<b>AMENDMENT OF SOLICITATION/MODIFICATION OF CONTRACT</b>				1. CONTRACT ID CODE <b>J</b>		PAGE OF PAGES <b>1   37</b>	
2. AMENDMENT/MODIFICATION NO. <b>0005</b>		3. EFFECTIVE DATE <b>27-Mar-2009</b>		4. REQUISITION/PURCHASE REQ. NO.		5. PROJECT NO. (If applicable)

14. DESCRIPTION OF AMENDMENT/MODIFICATION (Organized by UCF section headings, including solicitation/contract subject matter where feasible.)  <b>Add Questions and Answers</b>  The purpose of this modification is to add a new 00010 (price schedule), new 01010 (Scope of Work), and 01015 (Technical Requirements). Note, the entry control point was deleted and the number of barracks was reduced from 14 to 9. There are also three new diagrams: there is a new conceptual site plan, a drawing showing the electrical distribution and a new drawing for the security building  There are 18 pages of questions and answers following the price schedule. The Scope of Work begins on Page 20 and the Technical requirements begin on Page 44.  The new proposal due date is 9 April 09 1700 hours/5 PM Local time (Kabul Time).  Except as provided herein, all terms and conditions of the document referenced in Item 9A or 10A, as heretofore changed,

CSB Conceptual Master Plan  
Kandahar Afghanistan

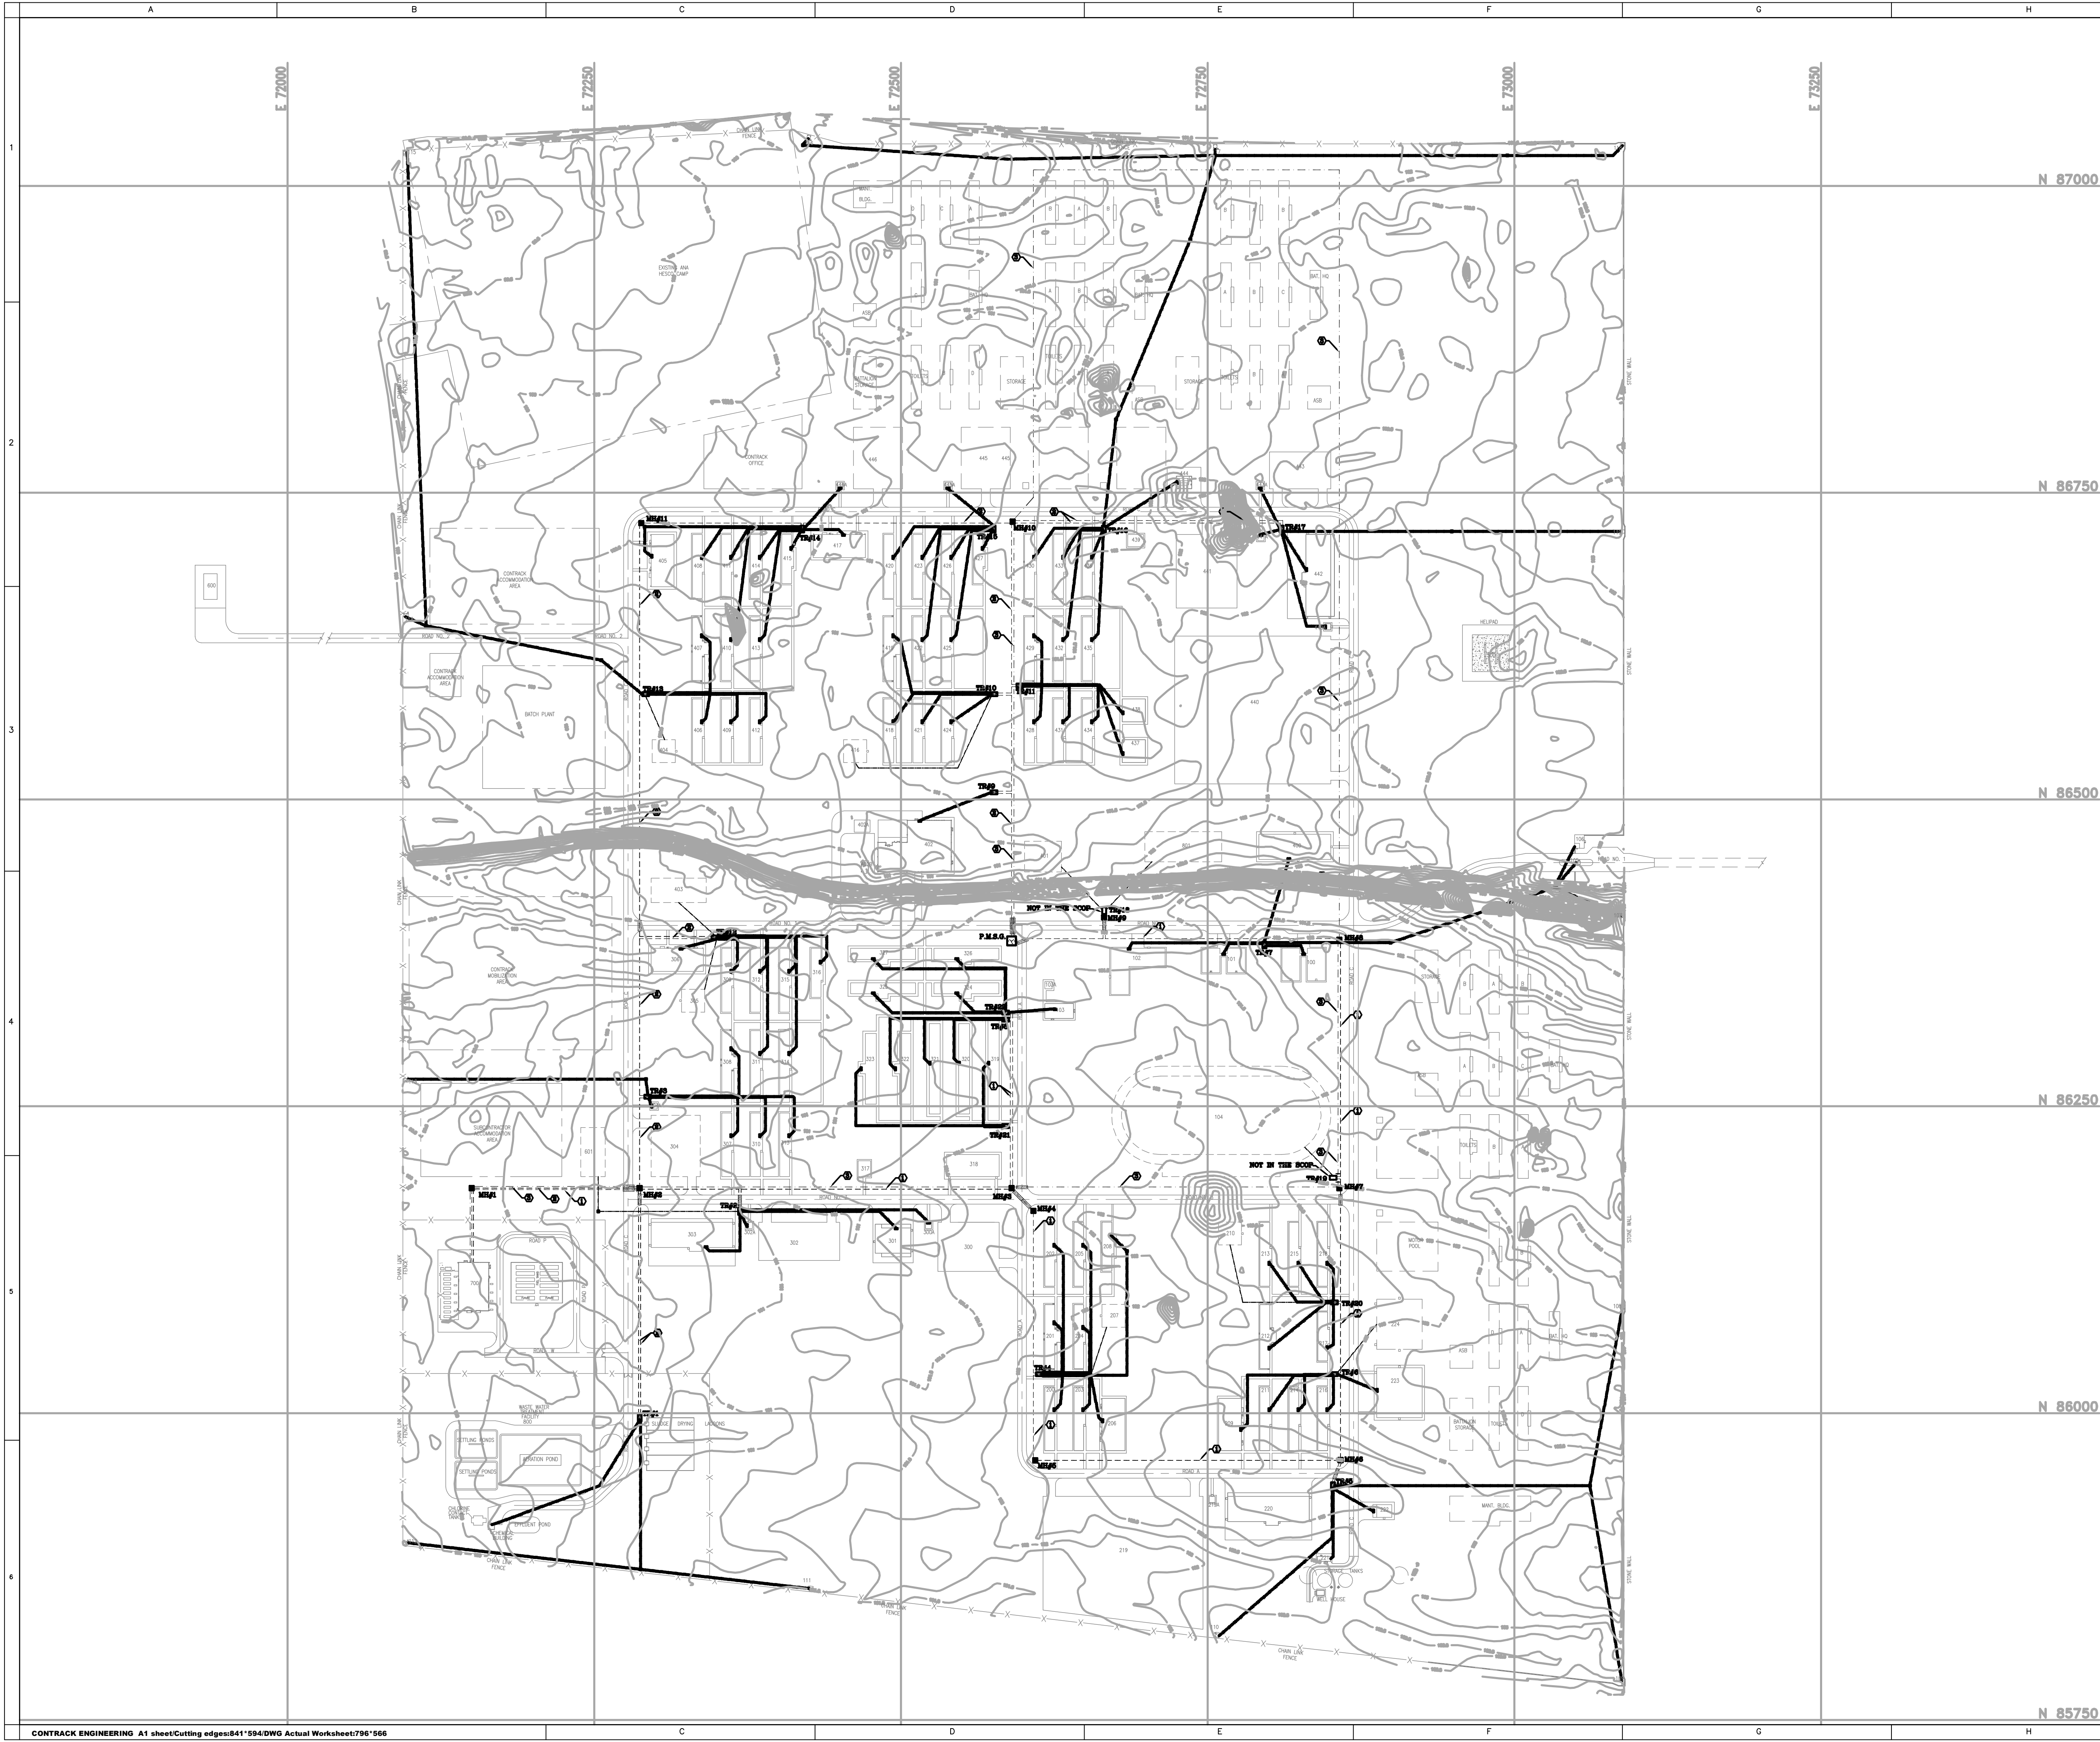
25. The legend on the CMP refers to Building 100 Administration and Building 122 Operation Administration Building. Can you please clarify which is the Bn HQ Administration Building.

26. Para 4.22 is titled Vehicle Maintenance Facility (9 Bay). The para specifies the Contractor is to design and construct a facility incorporating 18 bays. The CMP identifies 14 and 36 bay facilities. Please clarify.

27. Para 4.31 is titled General Non-Organic Vehicle Maintenance Facility (Two 9 Bay). The CMP identifies 14 and 36 bay facilities. Please clarify. PROPOSER CONTRACTORS REFER TO THE RFP SPECS FOR SPECIFIC SCOPE OF WORK GUIDANCE. THE CMP IS JUST THAT, A CONCEPTUAL PLAN AND NOT SPECIFIC. IT IS INTENDED FOR GENERAL GUIDANCE, NOT AS A DESIGN. YOU MUST FOLLOW EXACTLY THE SPECS 01010 AND 01015.

28. Para 4.32 is titled General Non-Organic Vehicle Maintenance Facility (9 Bay). The CMP identifies 14 and 36 bay facilities. Please clarify.

PROPOSER CONTRACTORS REFER TO THE RFP SPECS FOR SPECIFIC SCOPE OF WORK GUIDANCE. THE CMP IS JUST THAT, A CONCEPTUAL PLAN AND NOT SPECIFIC. IT IS INTENDED FOR GENERAL GUIDANCE, NOT AS A DESIGN. YOU MUST FOLLOW EXACTLY THE SPECS 01010 AND 01015.

PROPOSER CONTRACTORS REFER TO THE RFP SPECS FOR SPECIFIC SCOPE OF WORK GUIDANCE. THE CMP IS JUST THAT, A CONCEPTUAL PLAN AND NOT SPECIFIC. IT IS INTENDED FOR GENERAL GUIDANCE, NOT AS A DESIGN. YOU MUST FOLLOW EXACTLY THE SPECS 01010 AND 01015.

PROPOSER CONTRACTORS REFER TO THE RFP SPECS FOR SPECIFIC SCOPE OF WORK GUIDANCE. THE CMP IS JUST THAT, A CONCEPTUAL PLAN AND NOT SPECIFIC. IT IS INTENDED FOR GENERAL GUIDANCE, NOT AS A DESIGN. YOU MUST FOLLOW EXACTLY THE SPECS 01010 AND 01015.
